**UNITED STATES DEPARTMENT OF COMMERCE
National Oceanic and Atmospheric Administration**

Re: POA-2003-502-N, Ship Creek

The National Marine Fisheries Service (NMFS) has reviewed the Port of Anchorage (POA) Response to Public and Agency Comments, dated September 25, 2006, for Phase II of the Port of Anchorage expansion project. The Maritime Administration (MARAD) completed an Environmental Assessment (EA) for the port project on behalf of the POA. The applicant's preferred alternative, open cell sheet pile design (OCSP), would discharge fill material over approximately 135 acres of intertidal and subtidal waters of upper Cook Inlet and dredge 235 acres. Phase I of the project permitted 27 acres of intertidal fill area on the north end of the port. Phase II, if permitted as proposed, would discharge approximately 9.4 million cubic yards of material over the remaining 108 acres of intertidal and subtidal habitat and dredge approximately 633,000 cubic yards of material over approximately 47 acres for the construction of the proposed sheet pile dock. To obtain fill material, an additional 34.5 acres of wetlands would be impacted through the development of the Cherry Hill and North End

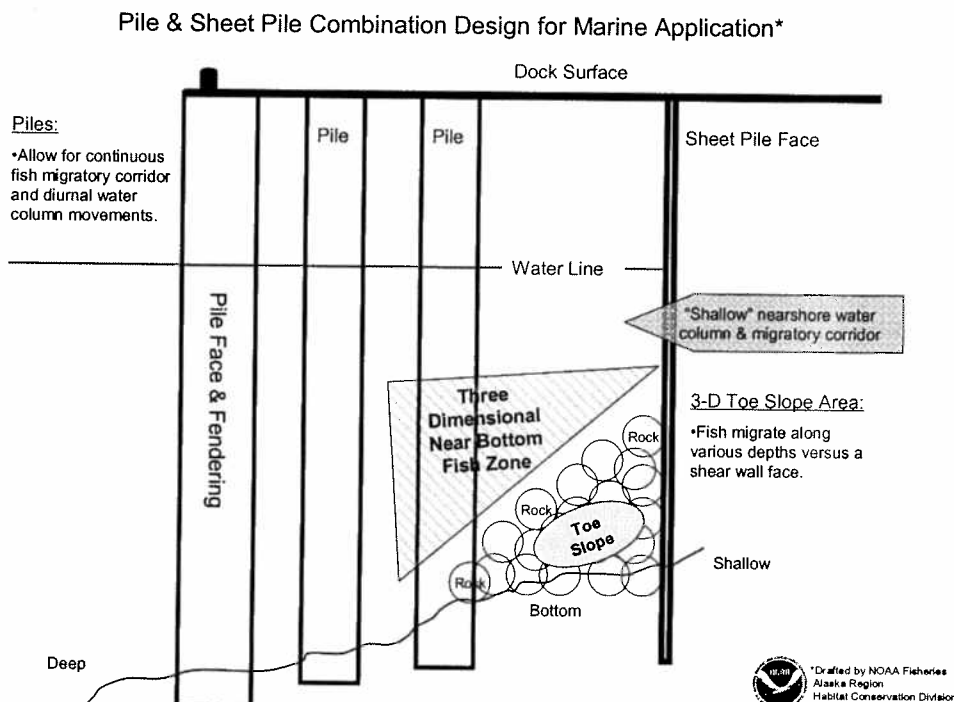
NMFS has consistently recommended pursuing an alternative design for the project that would significantly reduce impacts to living marine resources. Specifically, NMFS has recommended the use of a combination pile support and sheet pile design such as Alternative B in the Environmental Assessment or the Pile-Supported Dock with Slope (see Environmental Assessment page 2-30). Such a design would minimize the loss of nearshore habitat and provide shallow water, contoured slope refuge for out-migrating juvenile salmon and adults. Details on effects of the OCSP alternative on fish and EFH are outlined in our previous letters.

The following figure illustrates conceptually the type of design we would like to see analyzed in more detail. Although NMFS does not have expertise in structural engineering, this concept is based on our experience working on many port and harbor development projects in Alaska that incorporate cost effective design features to minimize impacts to fish habitat.
